Application No. 10/081,873
Paper Dated October 6, 2003
In Reply to USPTO Correspon

### **REMARKS**

Engine Enclosure Application No. 10/081,873 Inventor: Hiroki Nagai et al. Annotated Copy of Original

FIG.5

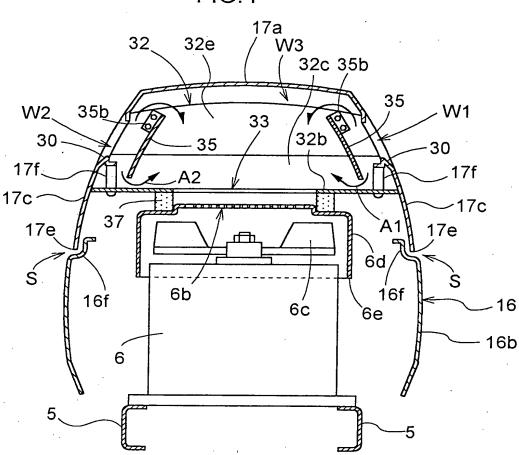
In amended Figure 5, the locations of reference numerals 16 and 17 have been corrected.

Fig. 5 stands objected to for incorrectly labeling reference numbers 16 and 17.

The Applicants believe that the above amendments to Fig. 5 overcome the Examiner's
